Accidental contact between bottom heater and back panel

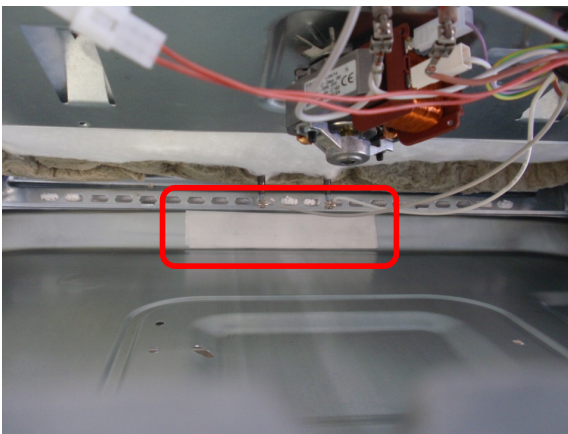
An accidental contact between bottom heater and back panel may occur in Sputnik ovens. This will lead to short circuit and discharge to ground. Possible result is shown on the picture below.
